## D/DRC Case

1300 Summerville Avenue

**Cottontown/Bellevue Architectural Conservation District**

**DESIGN/DEVELOPMENT REVIEW COMMISSION  
DESIGN REVIEW DISTRICT  
HISTORIC AGENDA  
EVALUATION SHEET  
Case # 4**

Damaged muntin indicated by arrow

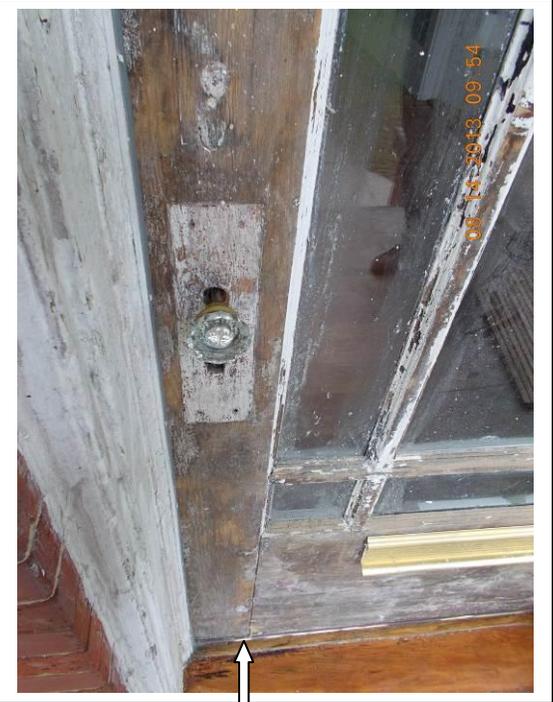
The door appeared to be very repairable when viewed by Staff. The owner has taken the door out to be repaired and has indicated that the door “fell apart.” The door was being used and appeared sturdy when viewed by staff, and a current photo supplied by the applicant shows that the stiles and rails are intact on the door, while the muntins and glass have been removed (please see attached). Repairing this door is possible and would meet the guideline; replacing the door does not meet this guideline.

Staff finds that the door previously on the building is likely original and therefore the proposal does not meet Section 7-1 of the guidelines. Staff recommends that the request for a Certificate of Design Approval for a new door be denied and recommends a time frame within which the applicant shall repair and reinstall the original door.

Close up views of damaged muntin from August 2013

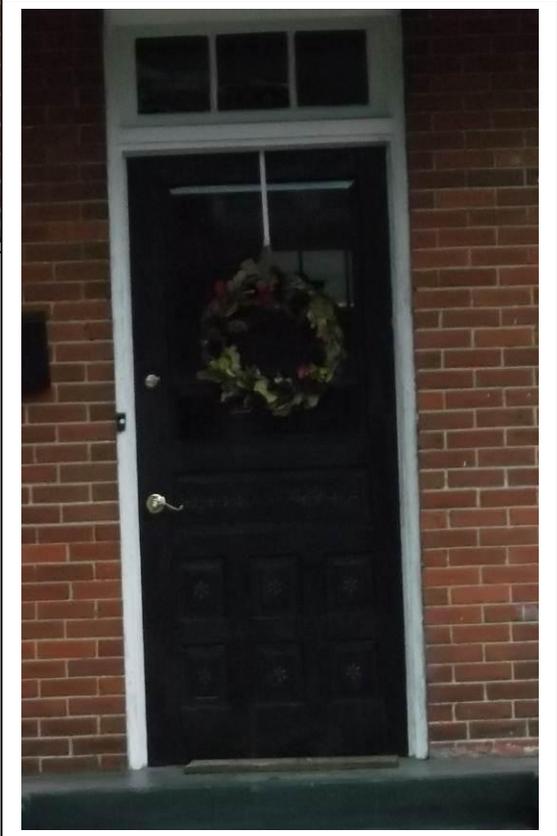
Damaged muntin indicated by arrow, central pane is broken in upper right corner

New Door

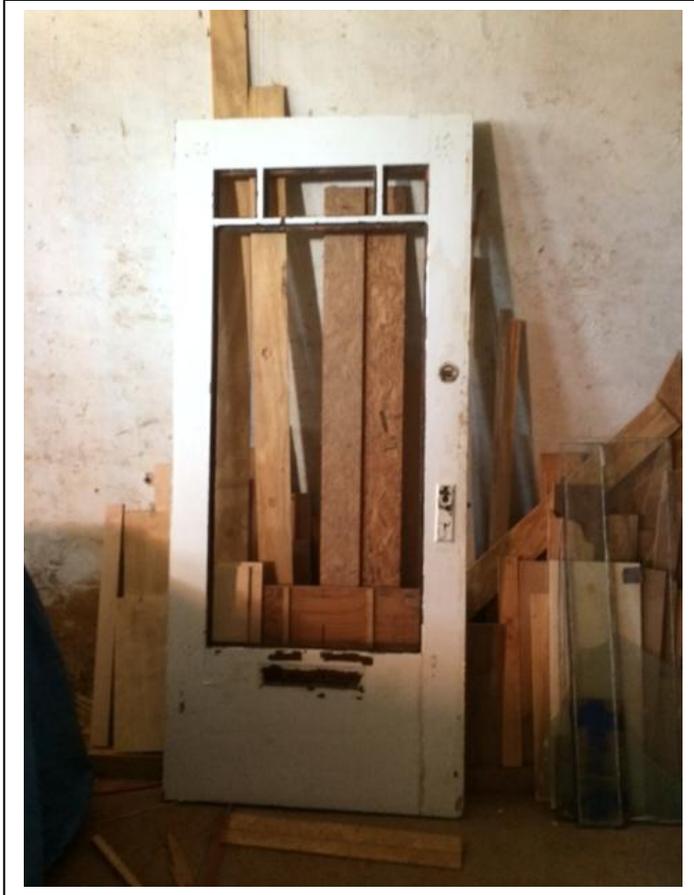
The door is not missing or deteriorated beyond repair. The proposed door does not closely match the original, nor is it of a compatible contemporary design, as it is a half-glass instead of a  $\frac{3}{4}$  glass door, does not mimic any of the muntin detailing, and features multiple raised panels and carving, instead of the flat, plain bottom of the original door.
